ONSITE SANITATION City of Portland – Bureau of Development Services
 1900 SW 4th Avenue, Portland, Oregon 97201 – 503-823-7300 – septic@portlandoregon.gov
SEPTIC REVIEW CERTIFICATION

Address of Proposed Work: 35320 SE Carpenter Ln Gresham OR 97080

Temporary permit for onsite construction administration office trailers at the Filtration Facility site. Trailers (likely 2-3 with restrooms) will drain to black tanks that will be pumped and taken offsite.

Permit No. 24-052313-SE
Date 7/24/24

Bull Run Filtration	REVISION	DATE	BY
Temporary Office			
Power Distribution

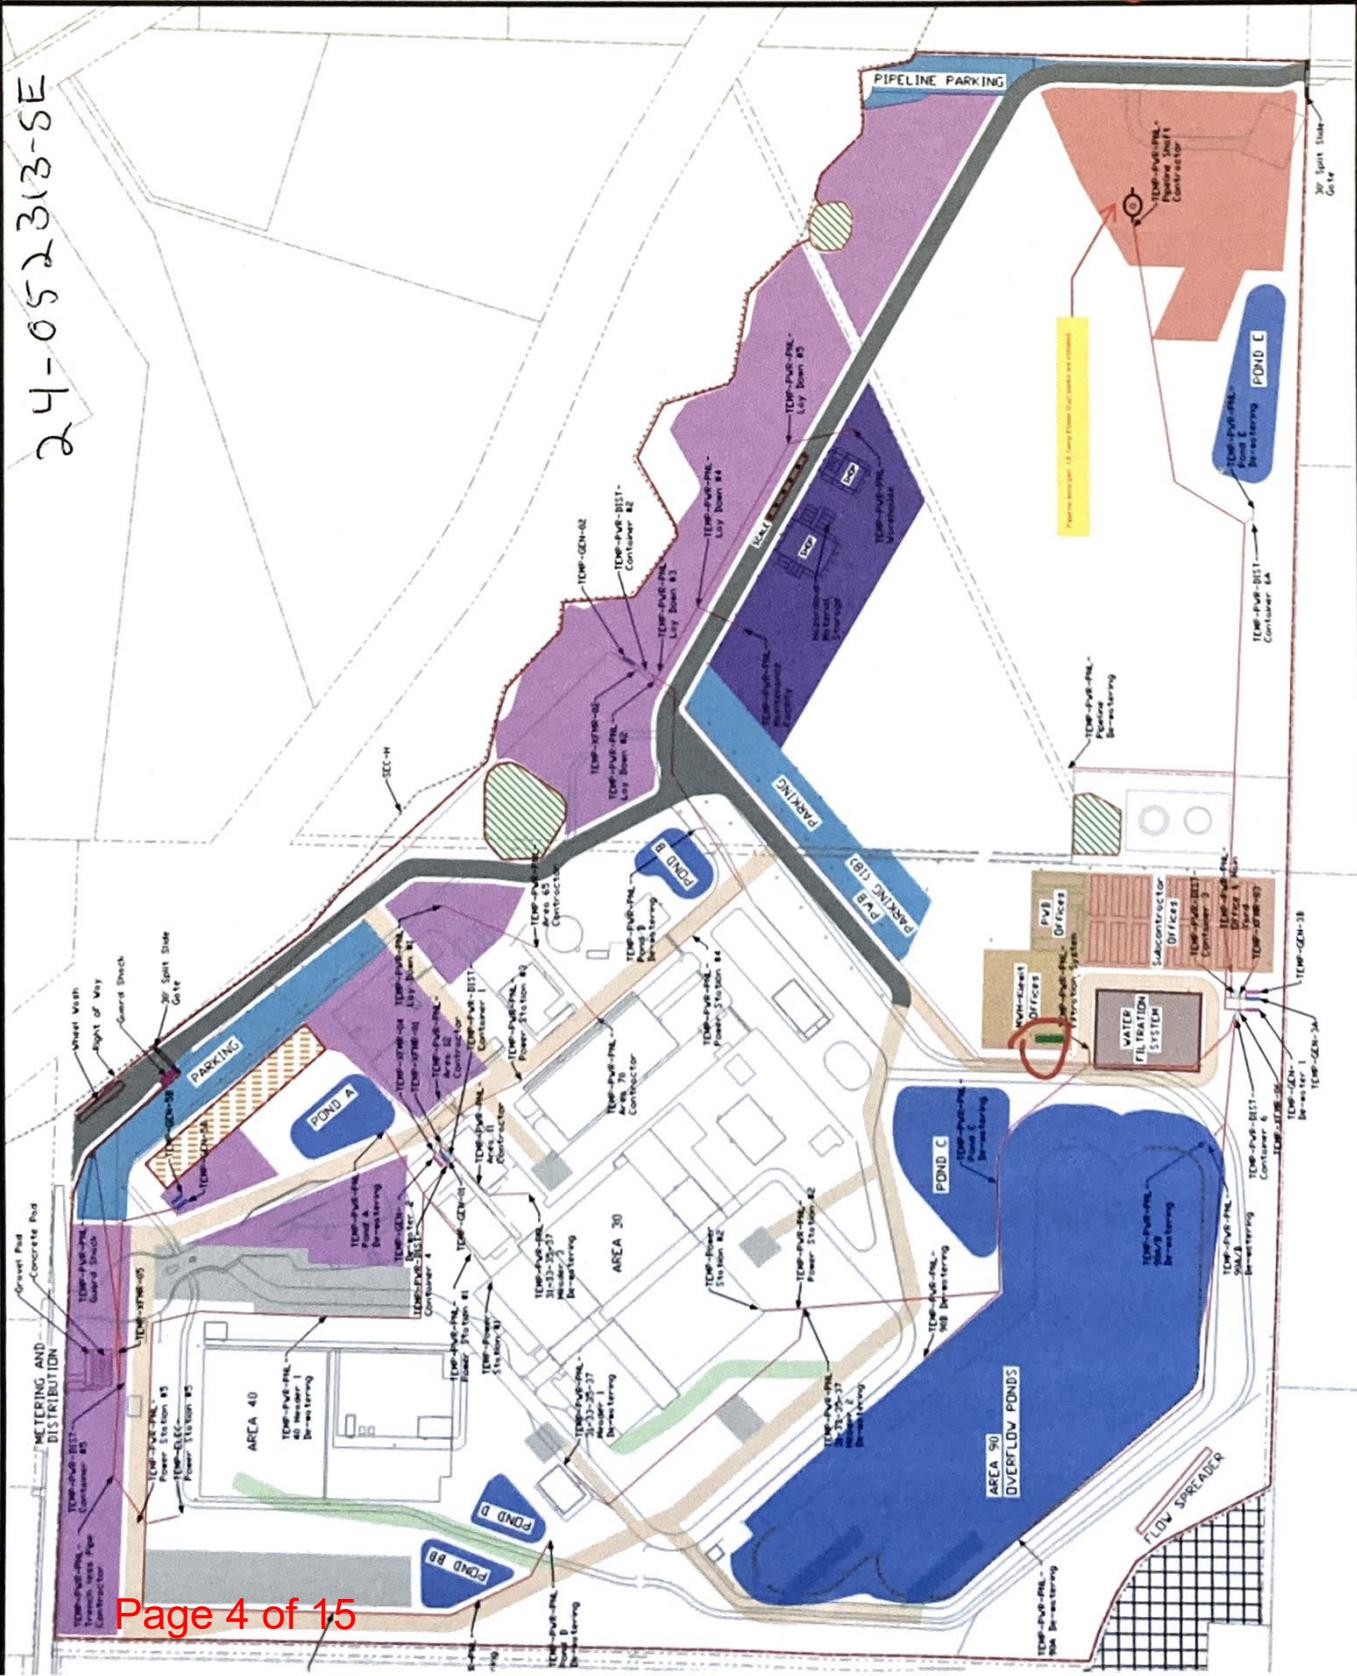
Proposed portable septic holding tanks for temporary toilet trailer meets requirements of OAR 340-071-0340 (5) provided tanks are marked w/name + phone # of licensed sewage disposal service responsible for maintaining the tanks + have a secure, water tight connection to the building sewer pipe. Signed pumping contract w/

48' x 12' TOILET TRAILER

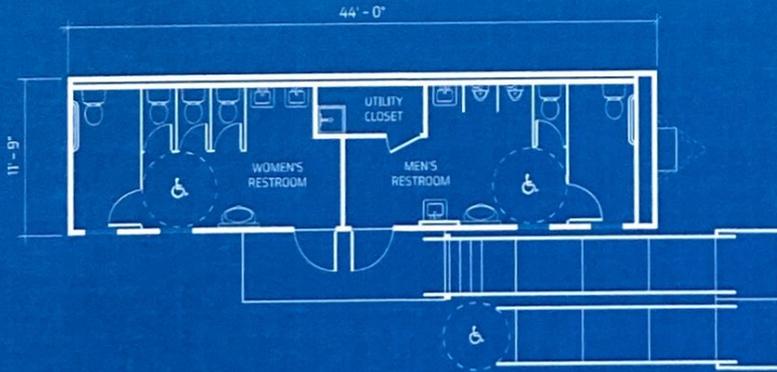
Thank you for the link. The max tank size on the link is 300 gallons. Will you be joining together two 300-gallon tanks?

Yes, the tanks will be joined.

We will be providing our holding tanks for this project. They will be connected together so we will not overflow at all. My drivers will check the tank every time we are on site taking care of the toilets.
